TECHNICAL EVALUATION REPORT

MASONRY WALL DESIGN

CALVERT CLIFFS NUCLEAR POWER PLANT UNITS 1 AND 2

NRC DOCKET NO. 50-317, 50-318

Figure 1. Response Spectrum Modification

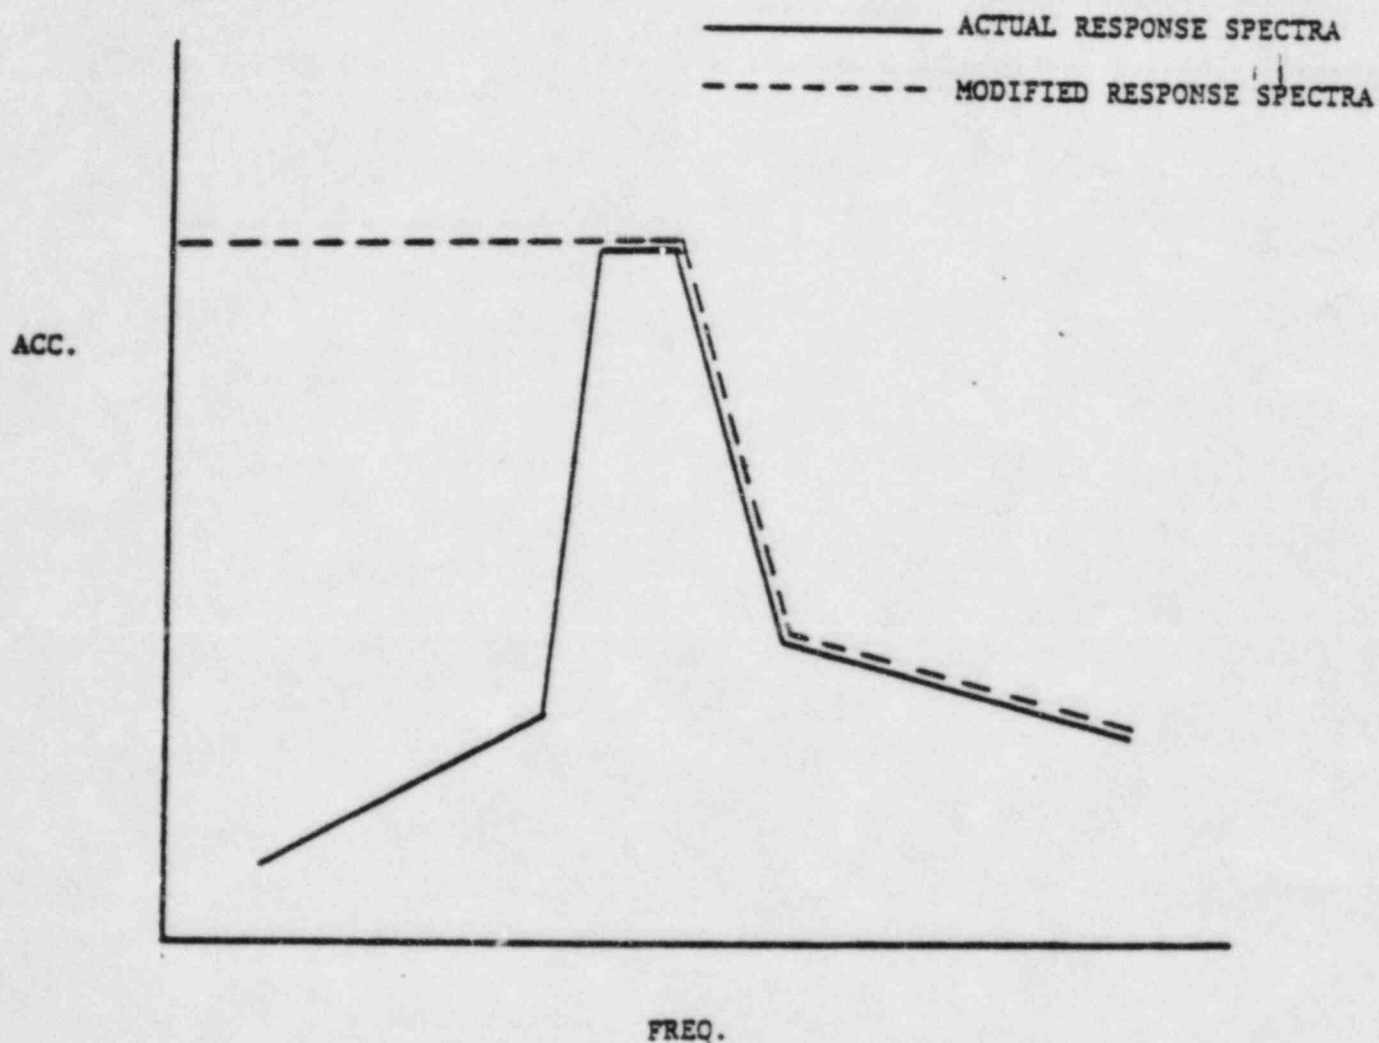
With respect to Section 5.2.1, Attachment D, Reference 2, the Licensee uses an increase factor of 1.67 for allowable masonry stresses in tension and shear, whereas the SEB Criteria allow only 1.3 for shear and tension normal to the bed joint and only 1.5 for tension parallel on the bed joint. The Licensee justifies the factor of 1.67 by claiming that it

provides a factor of safety of $1.8 = (3 \text{ divided by } 1.67)$. Substantiate this justification by any existing test data. The applicability of the tests should be discussed for the following areas:

- o Nature of loads
- o Boundary conditions
- o Sizes of test walls
- o Type of masonry construction (block type, mortar type, grouted, or ungrouted).

In addition, the Licensee is requested to indicate if the SEB Criteria were used, how many walls cannot be qualified, and to identify these walls.

In this response, the Licensee stated that, because all elastically qualified walls were analyzed as vertically spanning beam strips, the factor of 1.67 was used only for tension perpendicular to the bed joint. A list of eight walls was provided which would not qualify if the SEB criteria were to be used for tension normal to the bed joint. Also, the Licensee showed that actual shear stress values would fall within allowable limits even if the SEB factor of 1.3 were used instead of 1.6.

A table was provided listing the actual increase factors required to bring the walls within allowable limits and the percentage by which these factors exceeded the SGEB factor. The highest percentage of exceedance was 26% and the lowest was 11.5%. However, this increase could be compensated for by various conservative measures such as the conservative analytical assumptions of one-way vertical spans and a 2% damping value for these uncracked walls, in which masonry tension normal to the bed joint is used. In addition, whenever the natural frequency of the wall falls in the lower side of the peak response spectra, this peak value was used to obtain a conservative seismic loading as shown in Figure 1.
